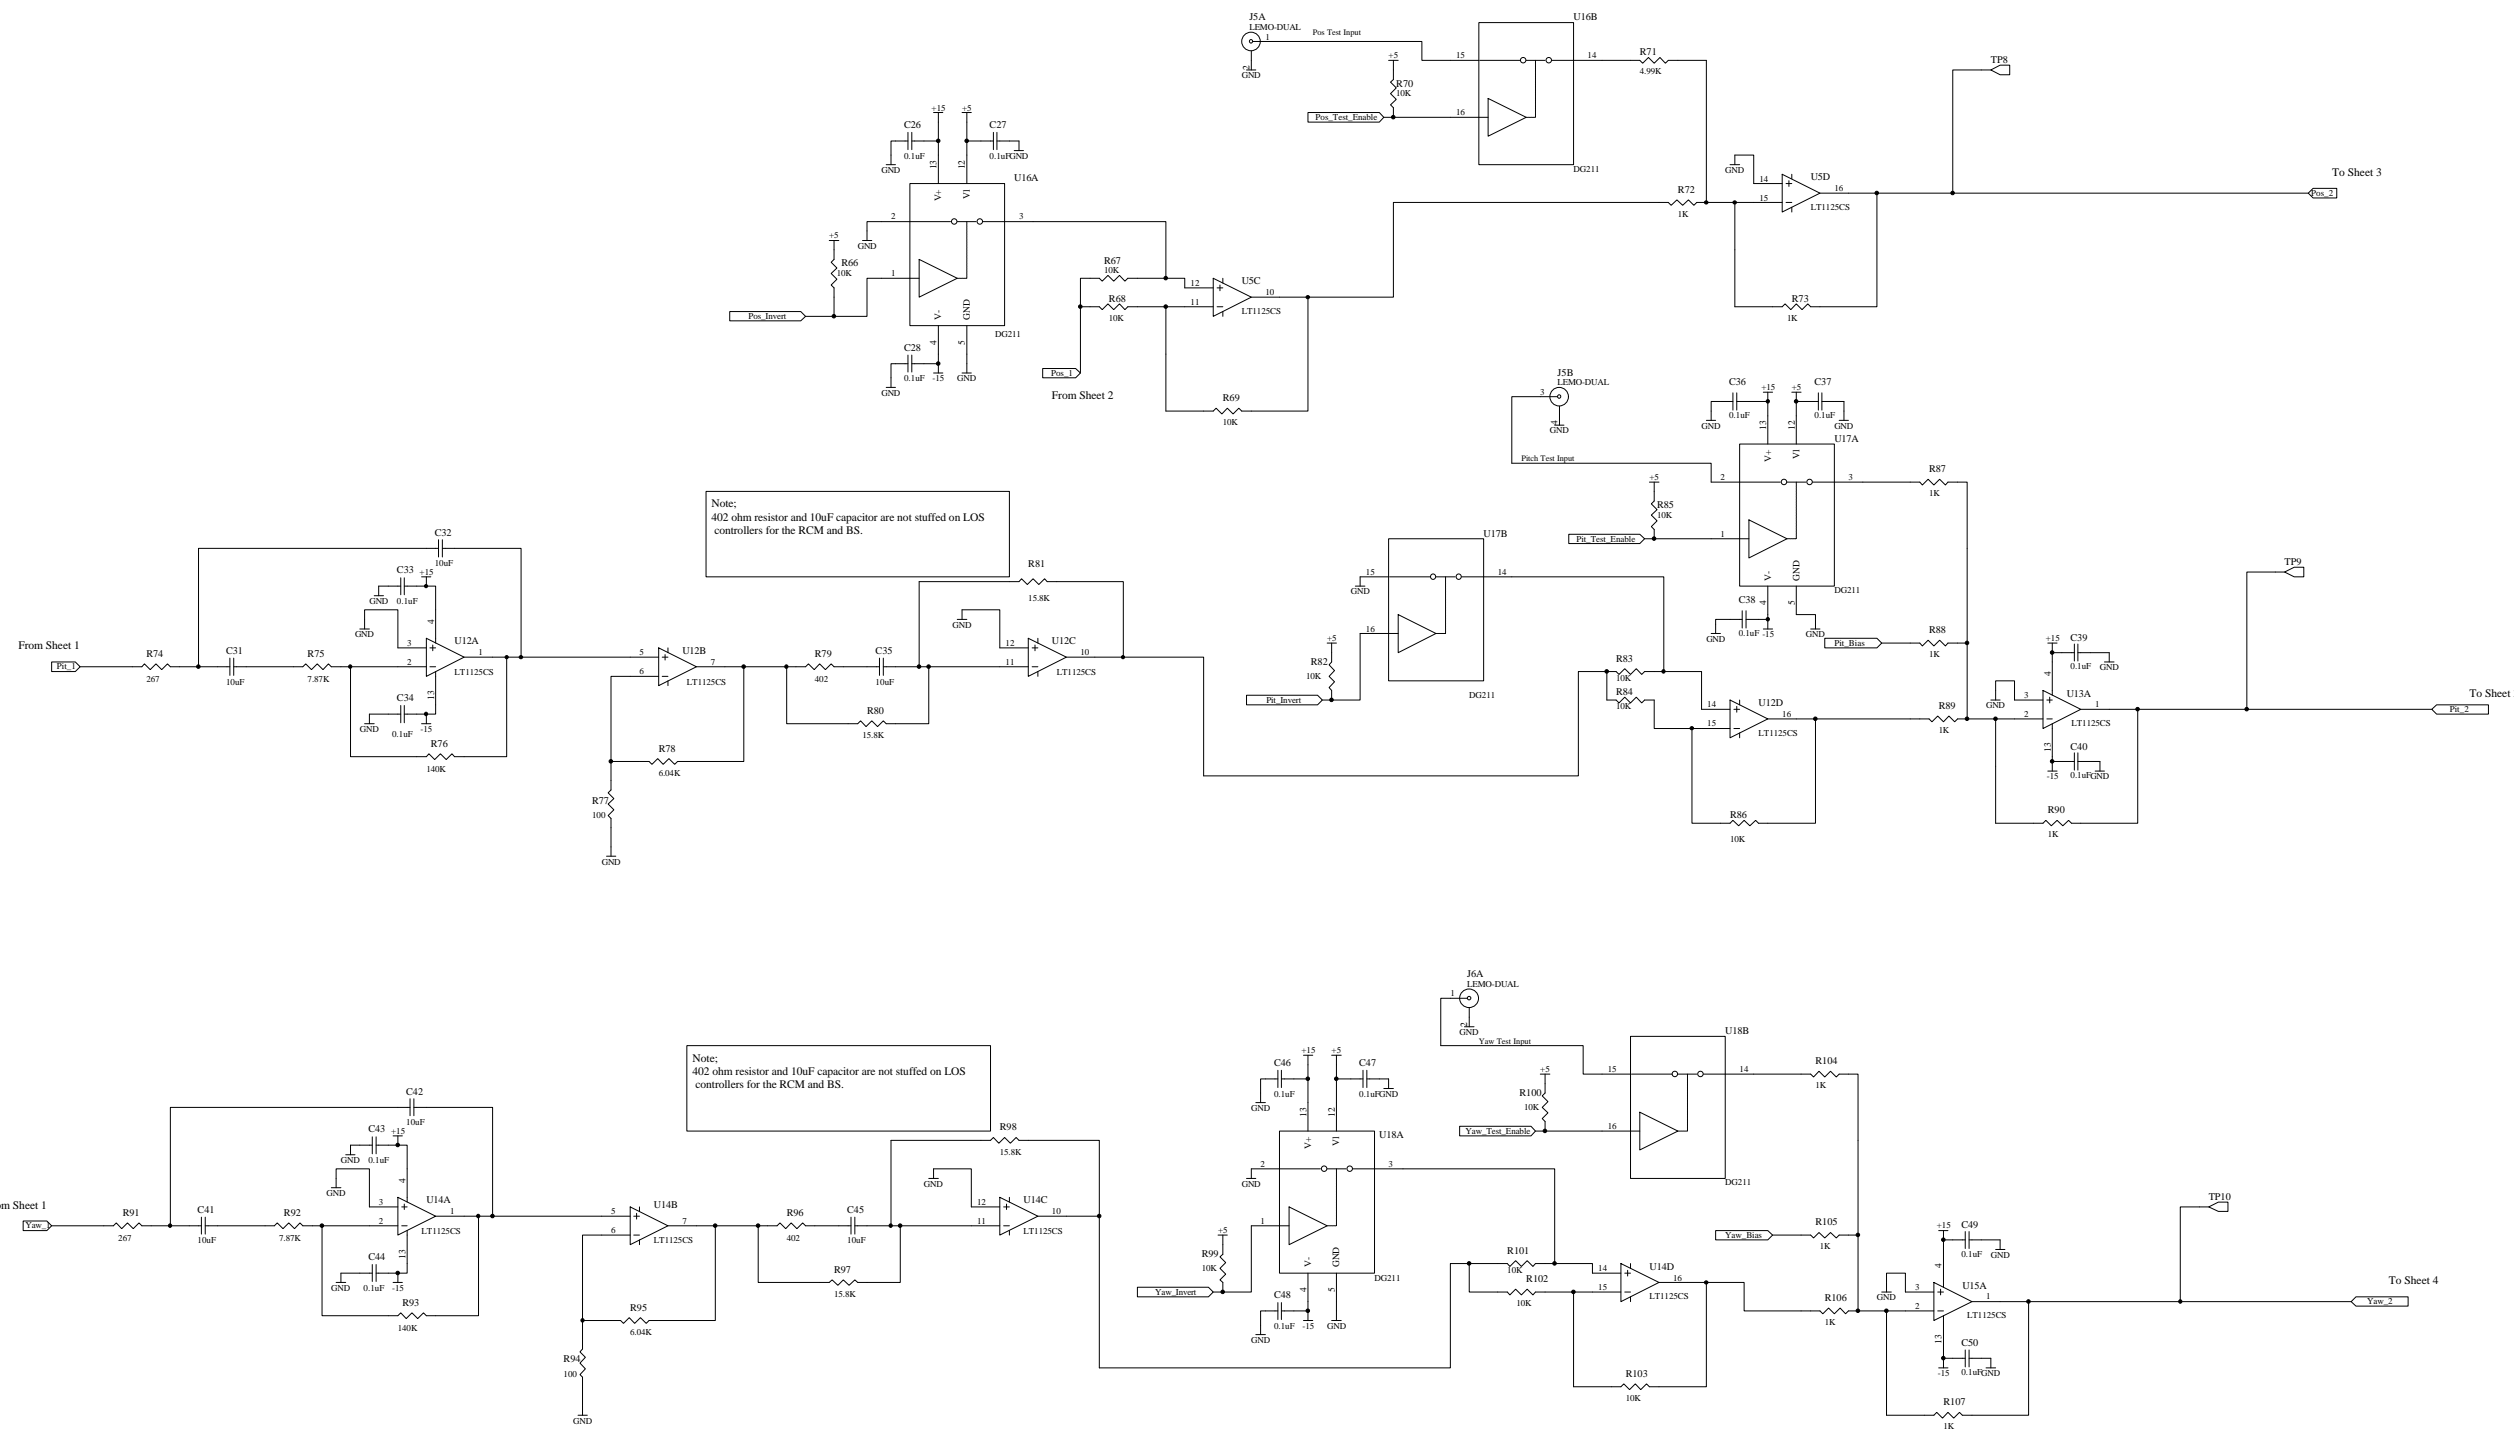
Note:
402 ohm resistor and 10uF capacitor are not stuffed on LOS controllers for the RCM and BS.

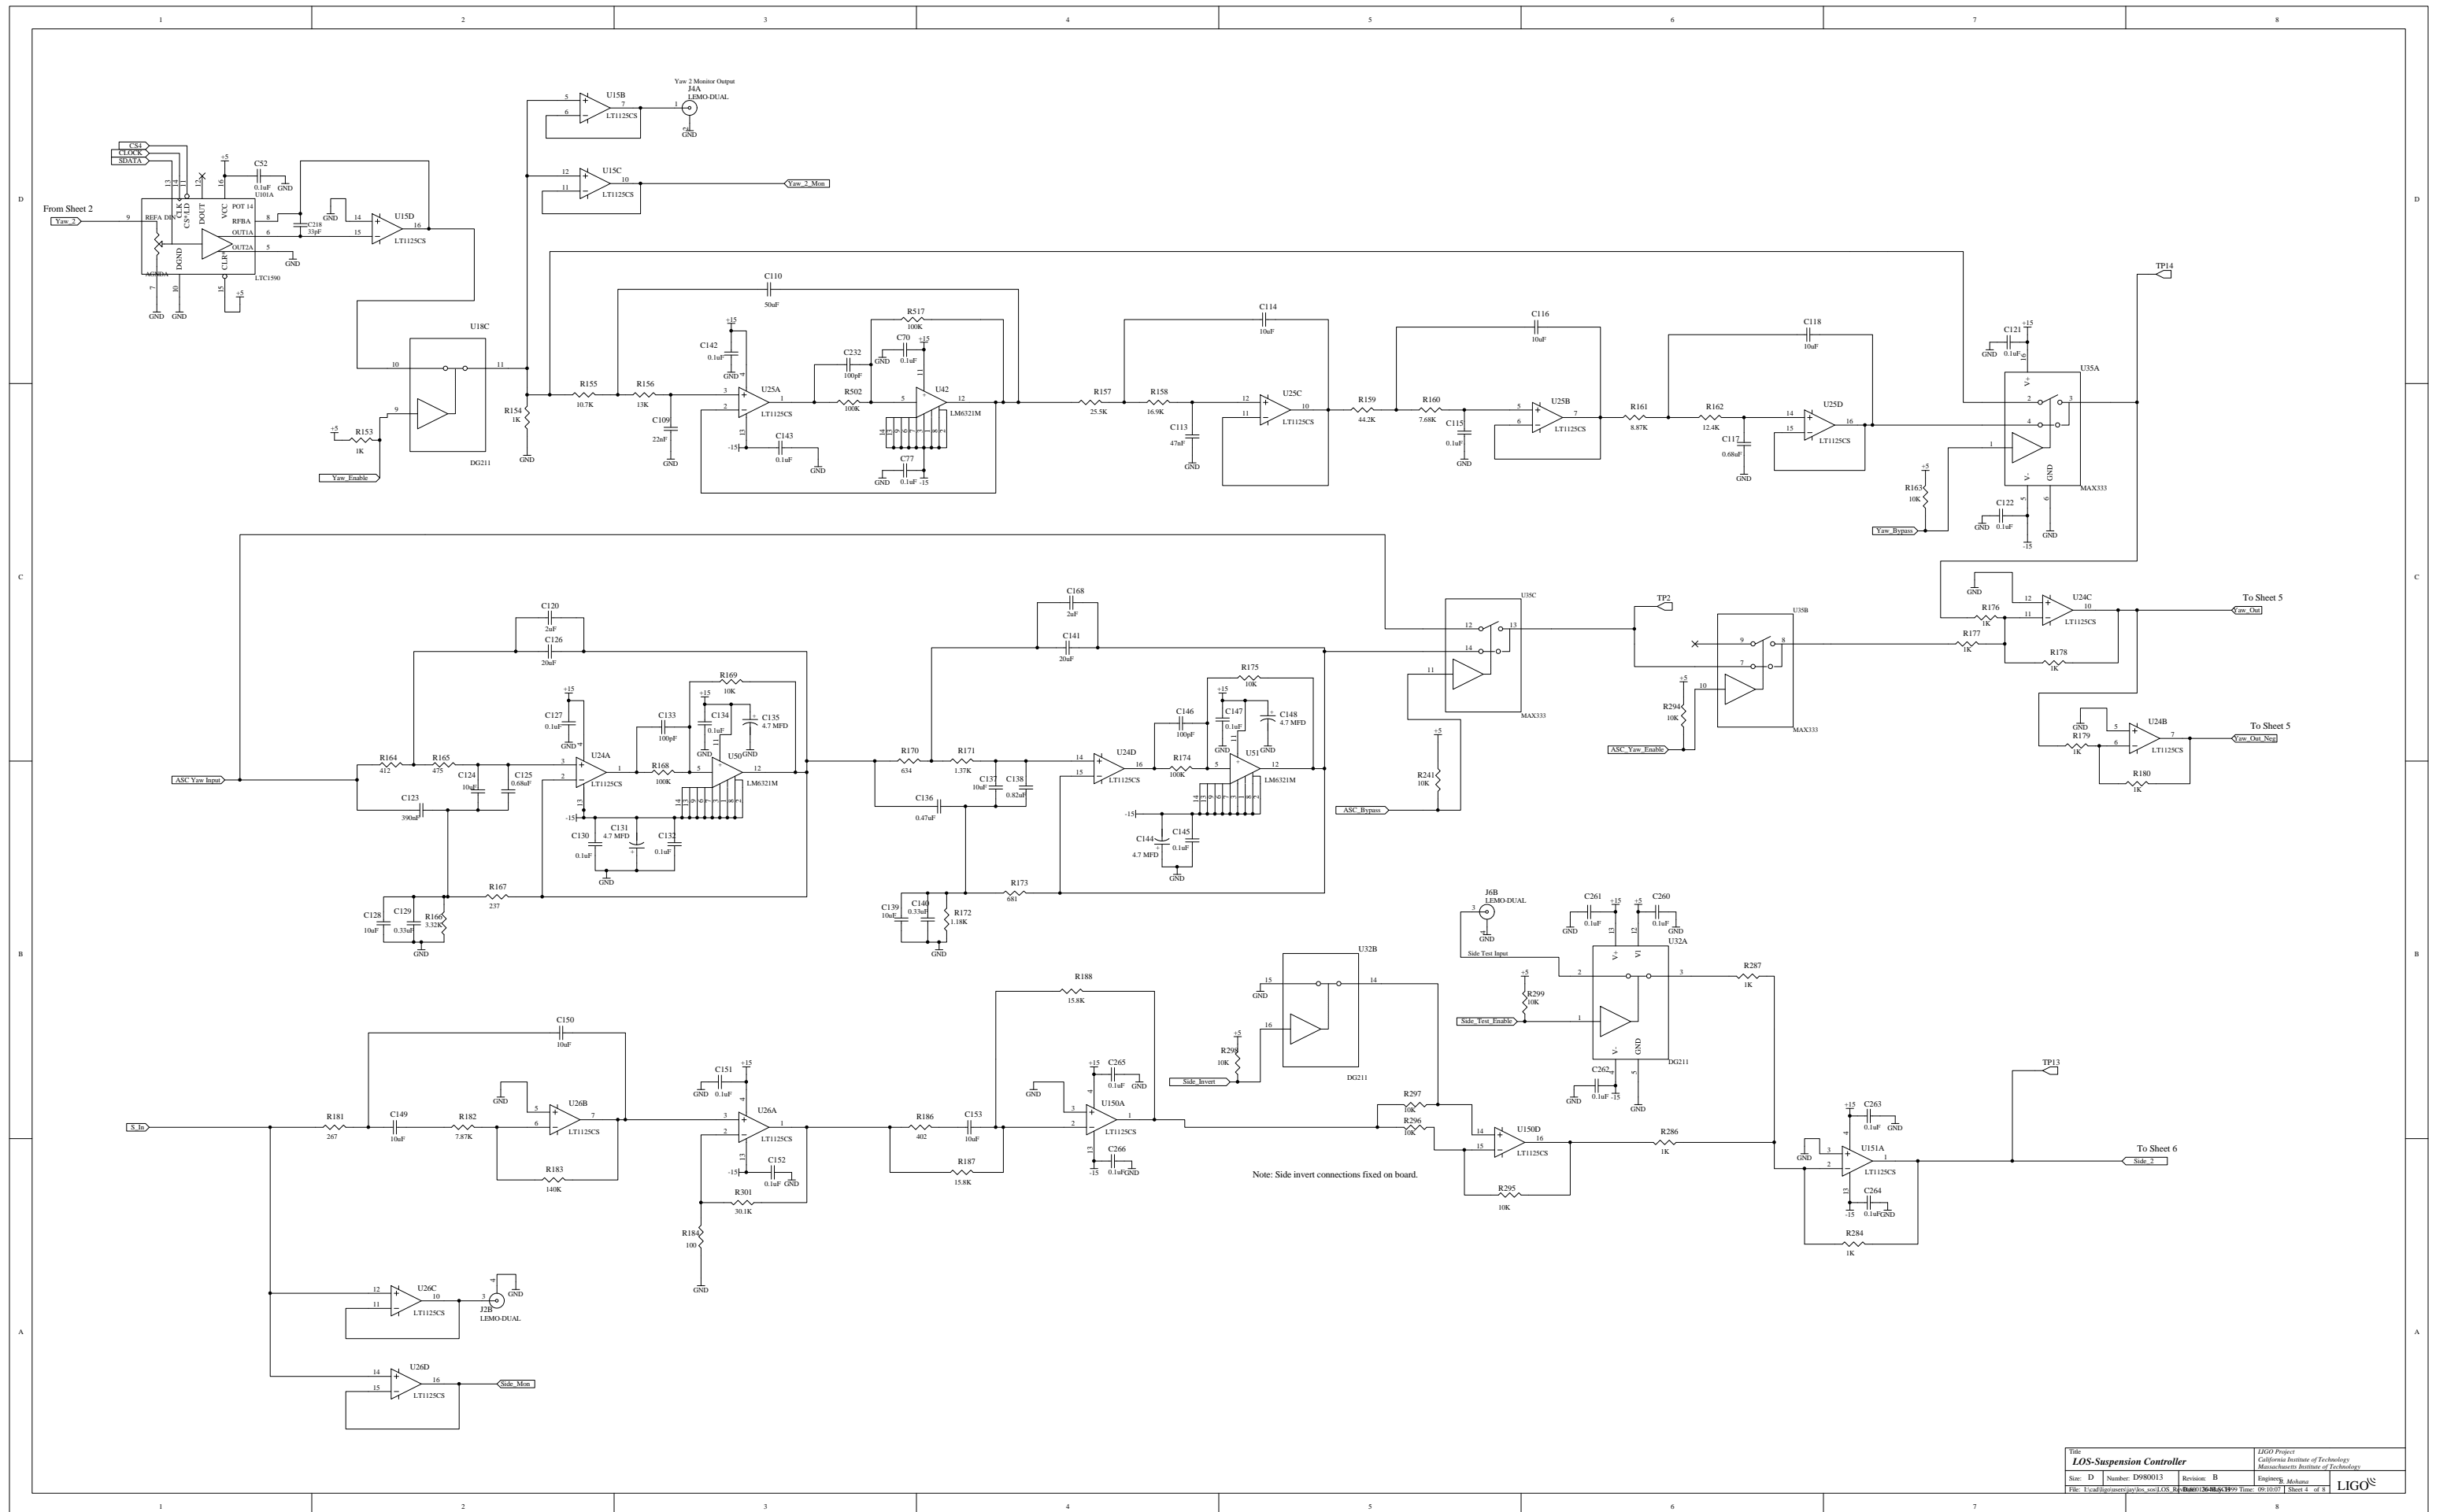
Note:
402 ohm resistor and 10uF capacitor are not stuffed on LOS controllers for the RCM and BS.

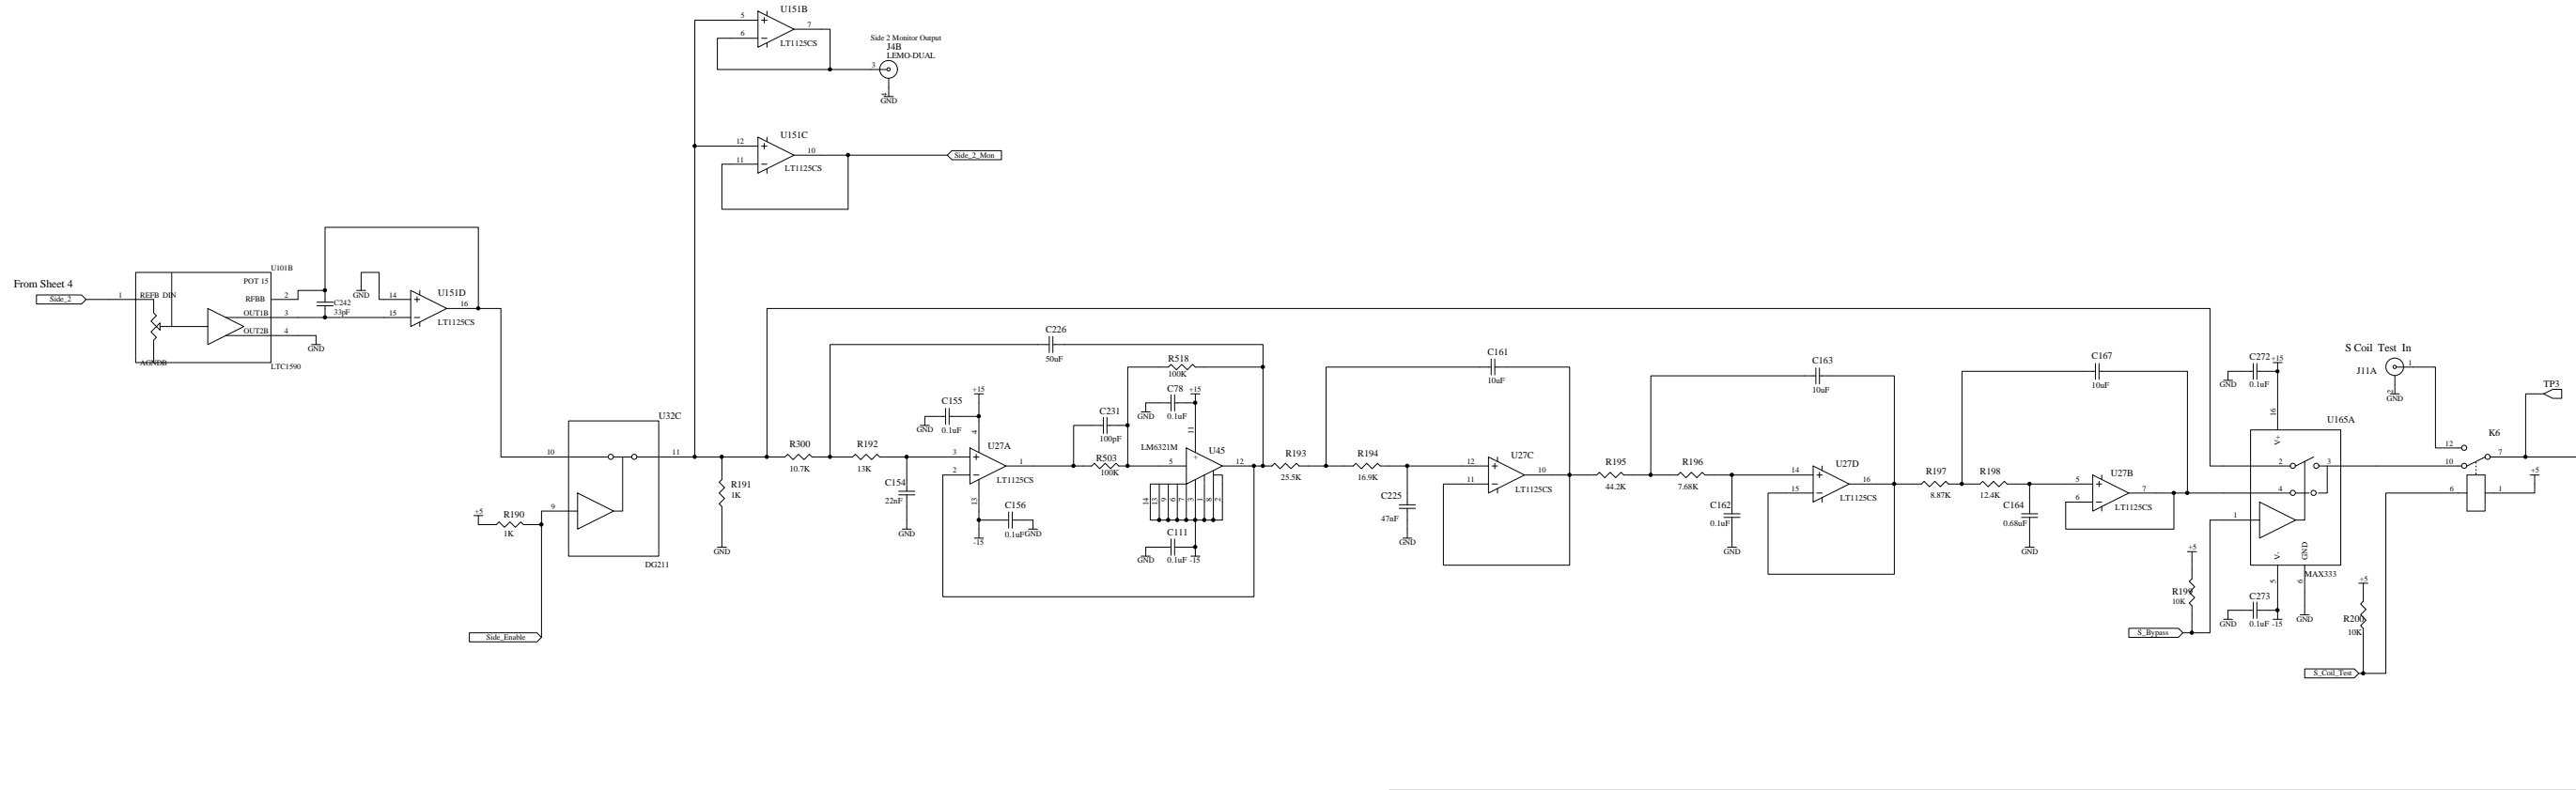
Note:
402 ohm resistor and 10uF capacitor are not stuffed on LOS controllers for the RCM and BS.

Note:
22nF capacitors are not stuffed on LOS controllers for the RCM and BS.
